**CITY OF SHERWOOD
FEBRUARY 3, 2022
STAFF REPORT AND NOTICE OF DECISION**

**Greenridge Solar
LU 2021-018 SP**

B. Application Summary: The applicant is requesting Site Plan approval for a new 17,365 SF industrial building including warehousing and office space at 20737 SW Olds Place. The 0.92-acre site is currently vacant and is zoned Light Industrial. Access is proposed from SW Olds Place and SW Arrow Dr. Associated site improvements include parking, landscaping, and underground utilities. The proposed development will serve as Greenridge Solar's new headquarters.

SITE PLAN & CODE SUMMARY
LU0.50

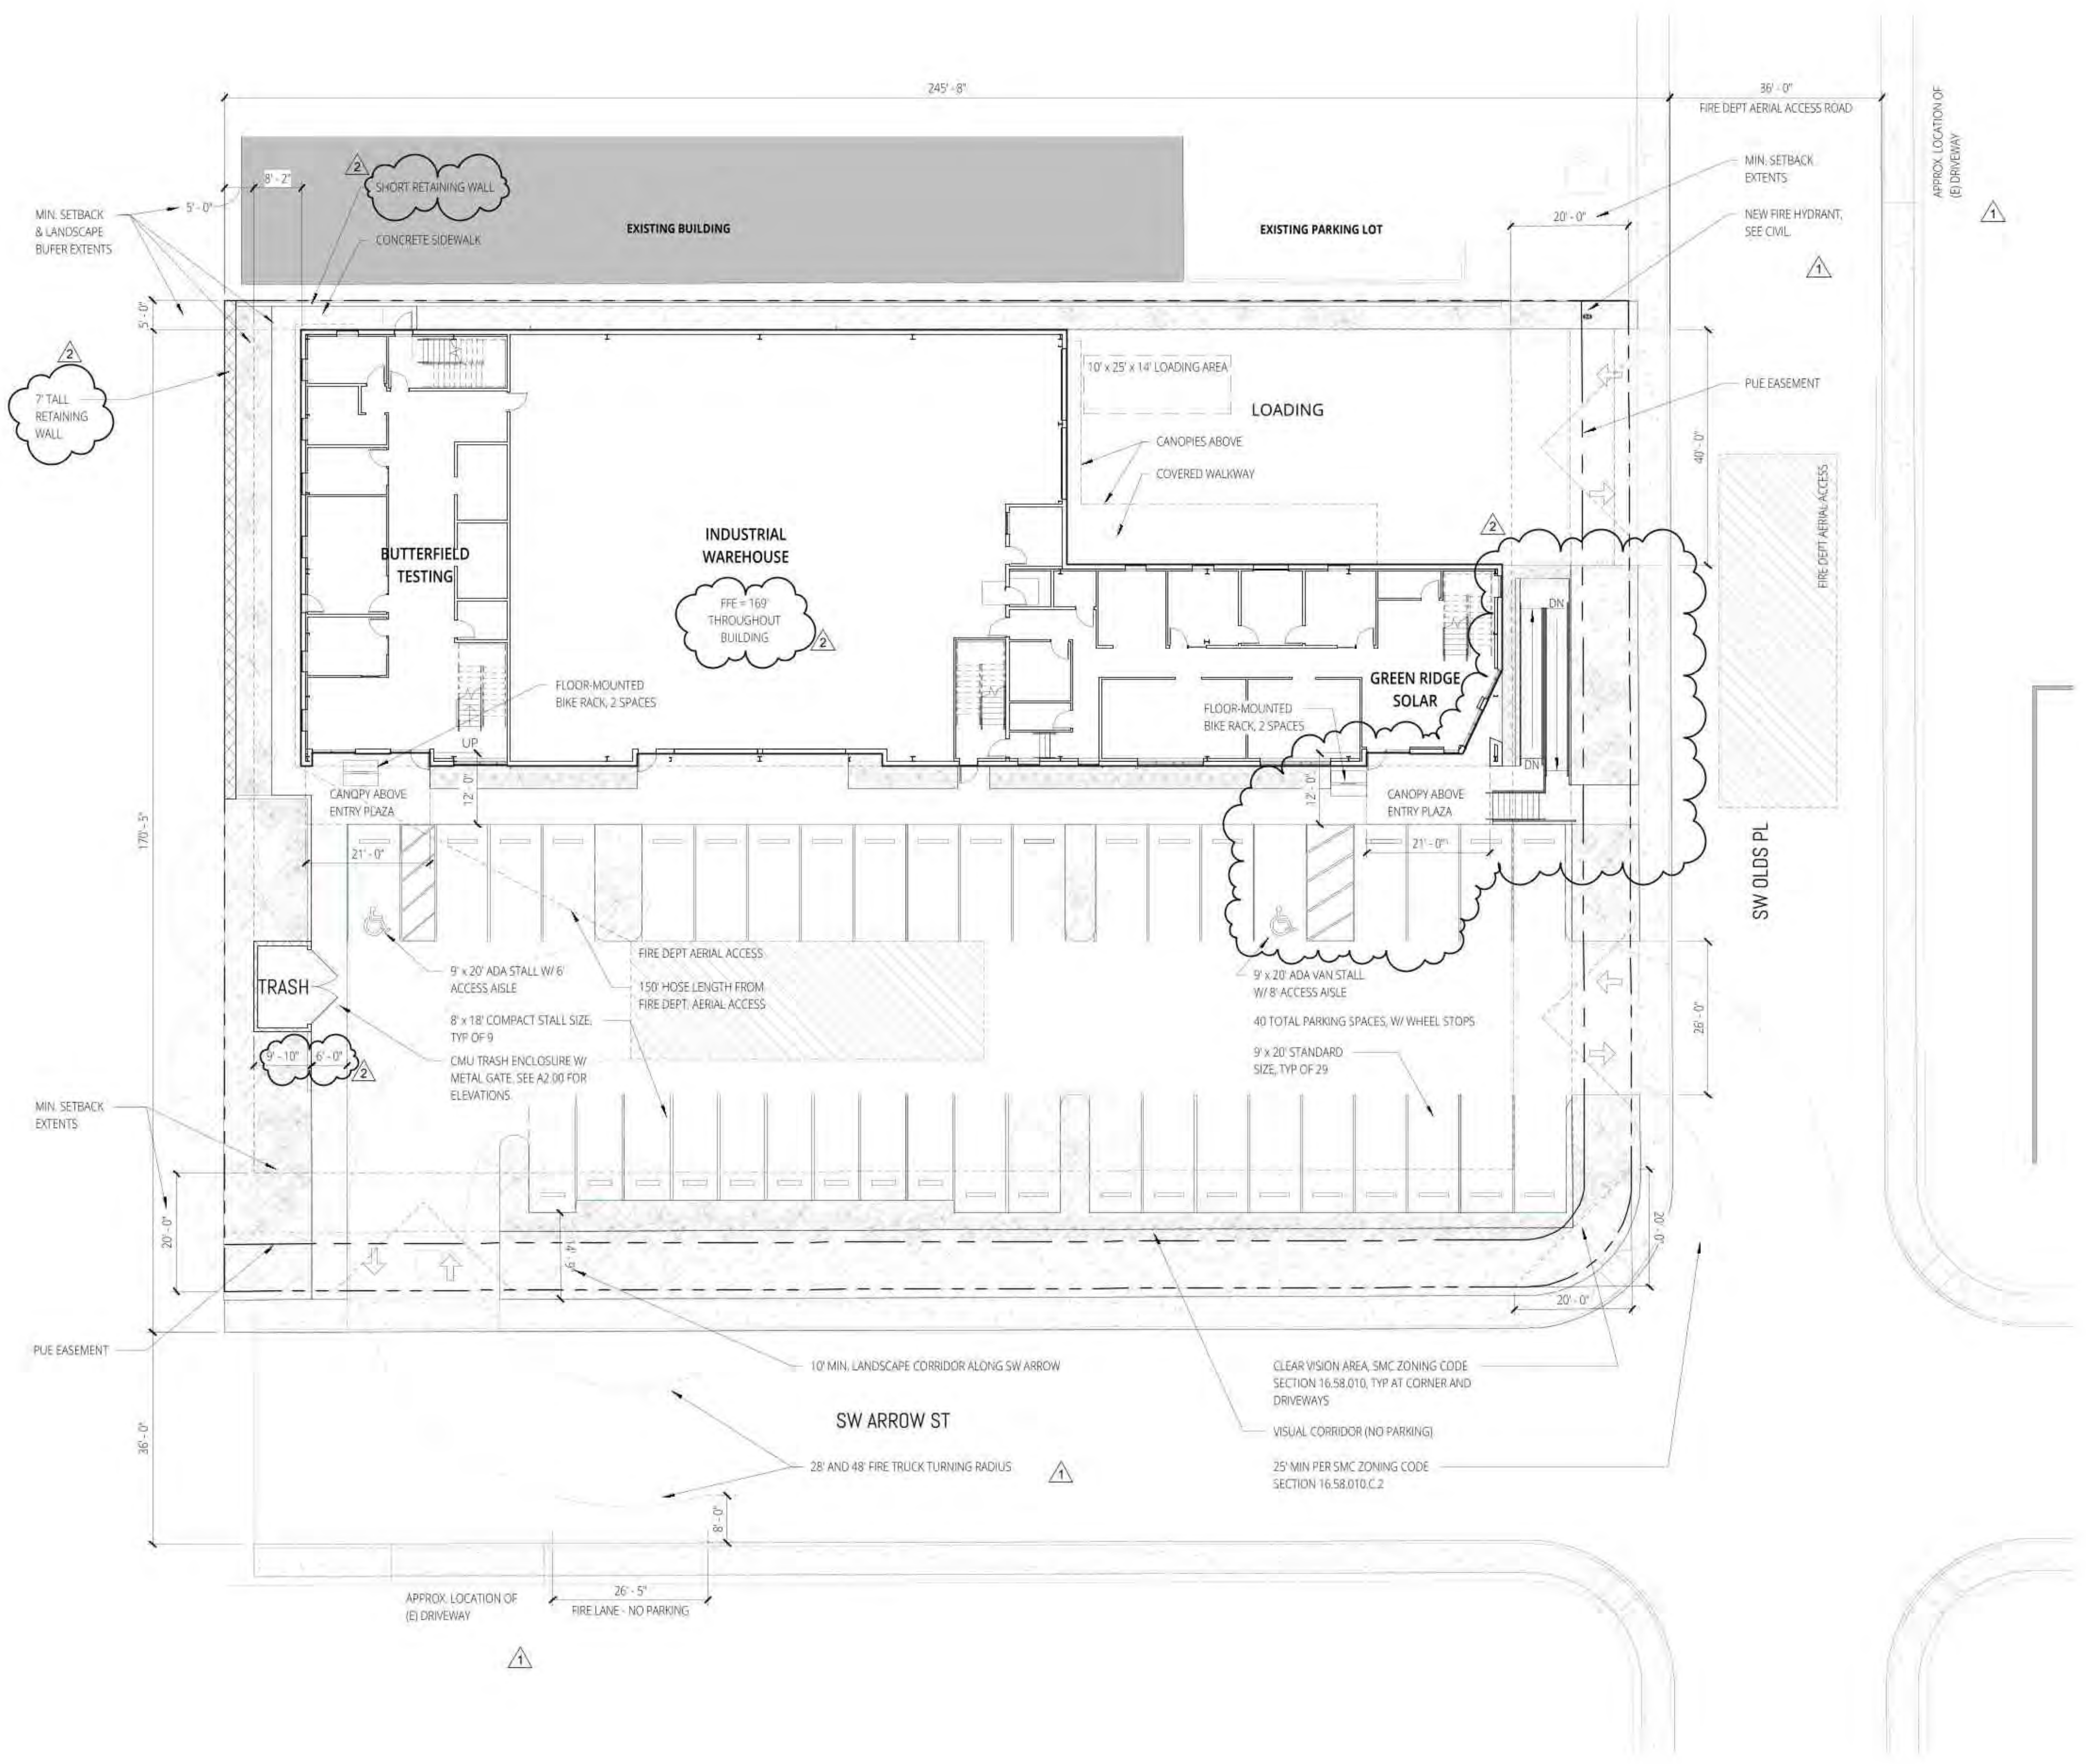
ANALYSIS: The Site Plan proposes three private driveway intersections with a private street. Clear Vision Areas are required at all three intersections. The plans show a clear vision triangle at each intersection, however, the area is not shown as required in the standard above.

ANALYSIS: Clear vision areas are shown on the plans but not in the correct location at each driveway.

CONDITION OF APPROVAL B1: Prior to Final Site Plan Approval, revise the Site Plan to provide Clear Vision Areas at each of the private driveway intersections with a public street.

5 TRASH ENCLOSURE - WEST ELEVATION
1/4" = 1'-0"

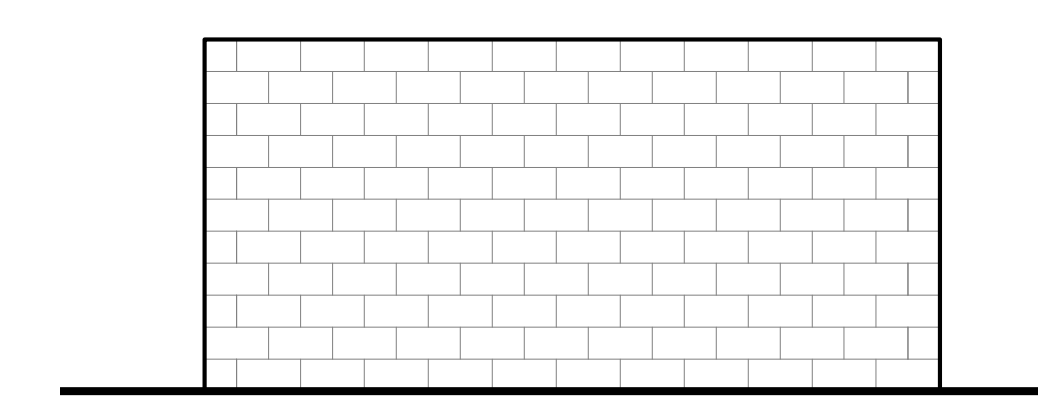
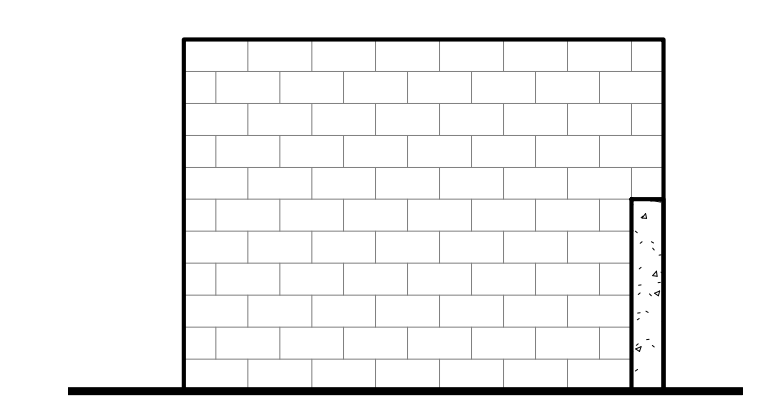
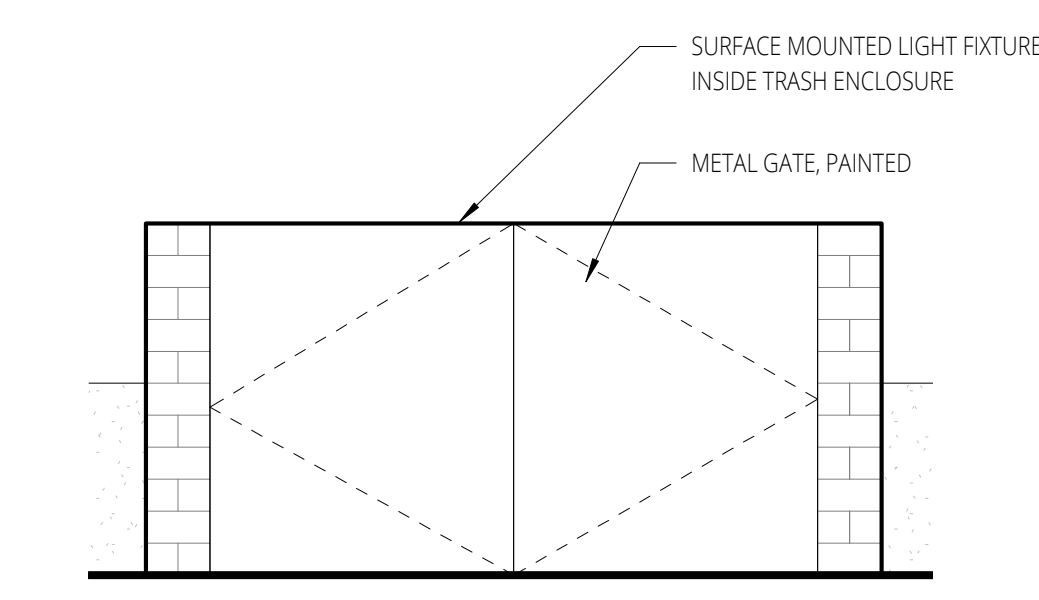
ANALYSIS: A trash enclosure is proposed along the western boundary of the site. The applicant is proposing a 6 ft. tall CMU enclosure with a metal gate (Exhibit A3 – Sheet LU2.00). The City did not receive a response from Pride Disposal regarding approval of the trash enclosure location or design.

RECOMMENDED CONDITION OF APPROVAL B2: Prior to Final Site Plan Approval, obtain written approval from Pride Disposal for the location and design of the on-site waste and recycling enclosure.
